Interactive comment on “Should seasonal rainfall forecasts be used for flood preparedness?” by Erin Coughlan de Perez et al.

Interactive comment on Hydrol. Earth Syst. Sci. Discuss., doi:10.5194/hess-2017-40, 2017.

Fig. 1. Correlation of seasonal average runoff and floodiness for FPU's in Africa. These are anomaly rank correlations between runoff and percentage floodiness at the 5-year return period at the FPU level.

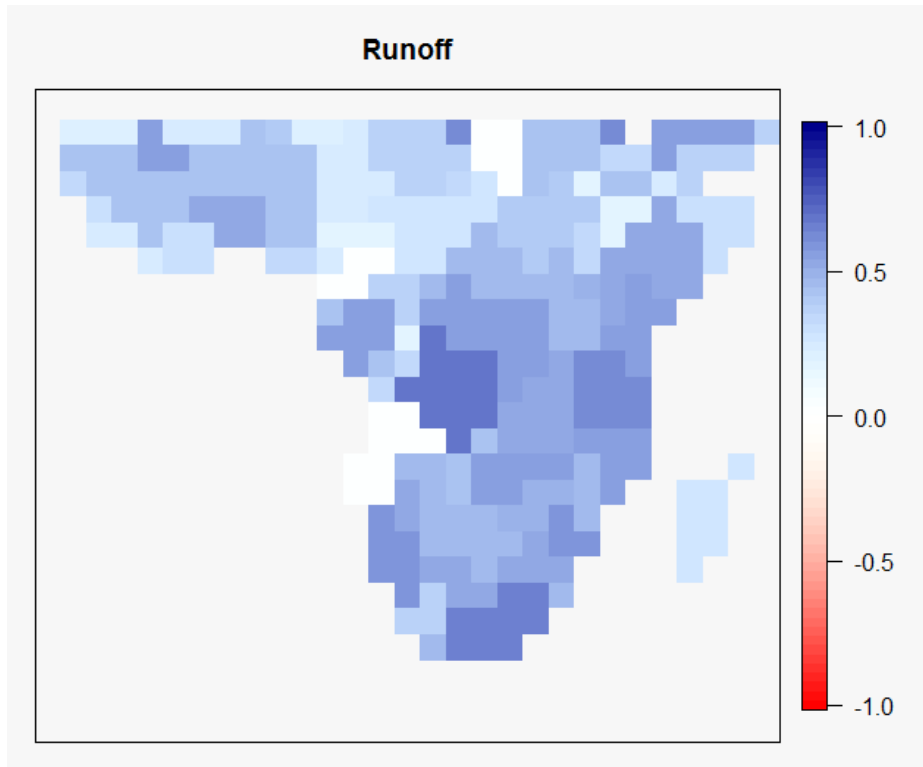
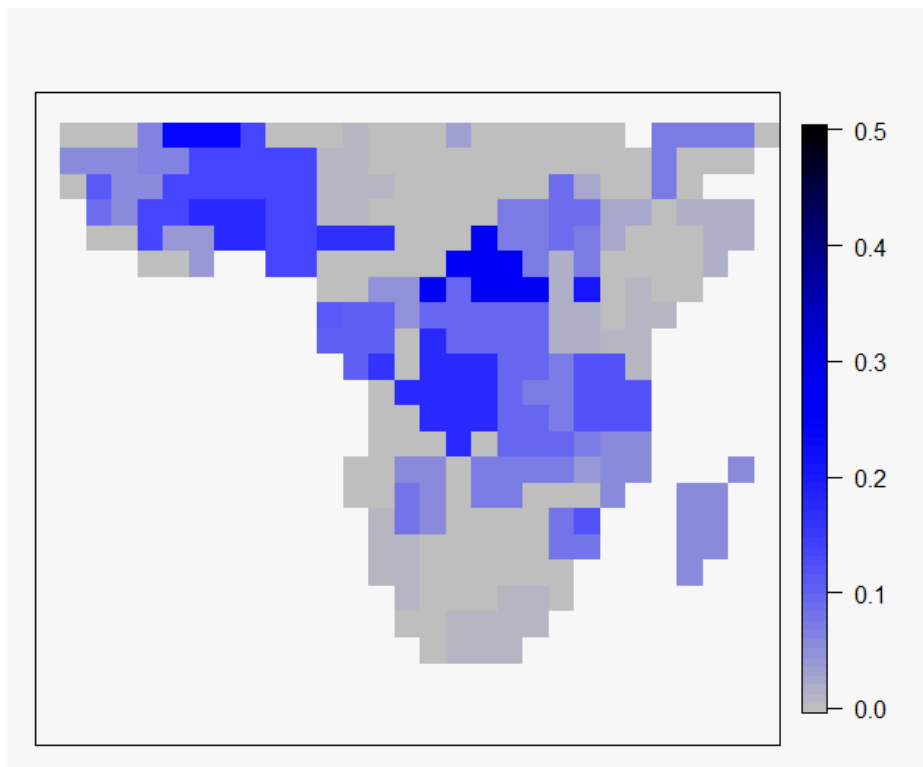
COMMENT: (4) Given many seasonal GCMs also produce surface runoff, I wonder

whether the authors would like to comment on the value of using surface runoff forecasts from the GCMs.

RESPONSE: Indeed, this is a good point. We refrained from including surface runoff in this paper, as it is no longer a rainfall indicator, but rather a rudimentary hydrological model. In the conclusions section, you can see that we do suggest people consider developing and running different seasonal hydrological models to provide specific floodiness seasonal forecasts, but we have not attempted to identify and evaluate those models that exist.

However, we did indeed analyze runoff from the ERA-Interim Land dataset, and the results are promising, in that even a crude hydrological model can greatly improve the correlation with floodiness. In case of interest: you can see the results at the end of this comment as per Figure 2 in the manuscript.
